Technical change to 3- and 4-pole unshielded M12/M8 Adapter cord sets

1. General overview

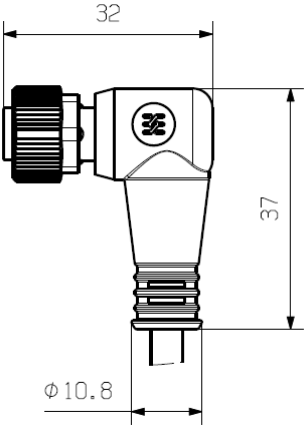
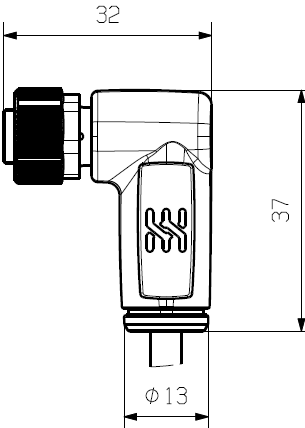
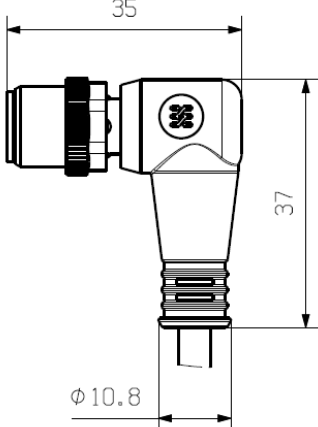
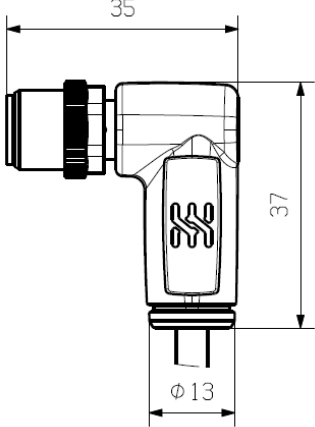
The 3- and 4-pole unshielded M12/M8 Adapter cord sets are currently lead-free in accordance with the ROHS directive with the exception of 6c. To make the articles sustainable, the new design will be lead-free, without the exception 6c.

Old design	New design
M12 socket straight

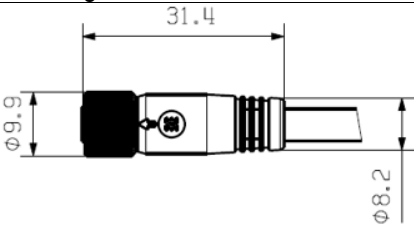
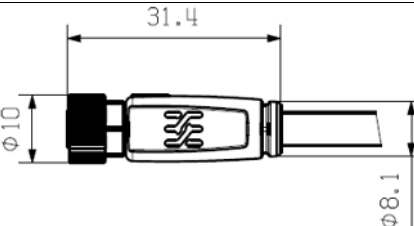
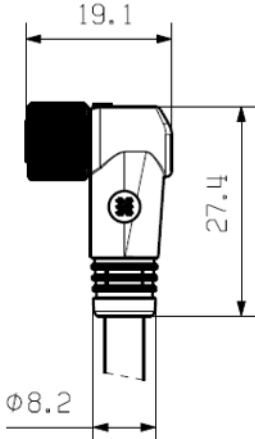
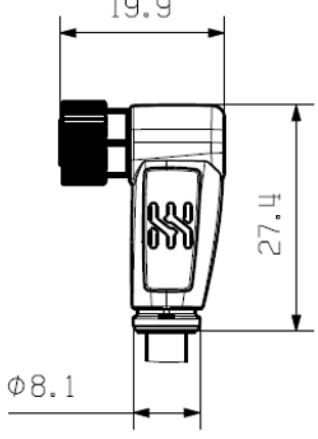
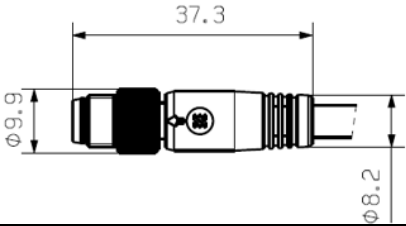
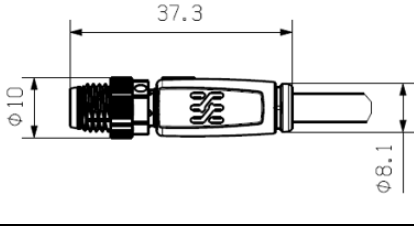
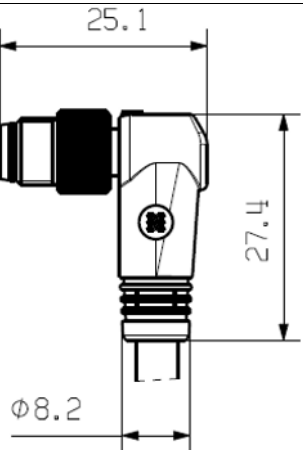
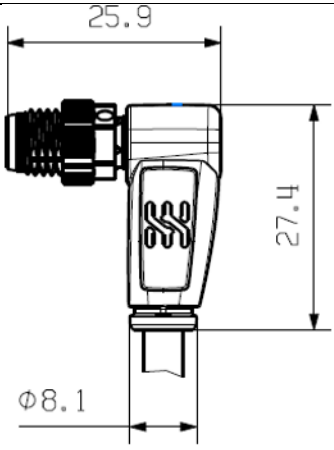
Until now, lead-containing materials were used for some components of the affected articles. As part of the changeover, these will be converted to lead-free materials so that the products in the new design comply with the RoHS Directive without the exception 6c. The new design changes the dimensions of the protective tube adapter at the M12 Side from 10,8mm to 13mm and the M8 Side from 8,2 to 8,1 mm. The new design will change the Dimensions slightly. See the Table Below for Details.
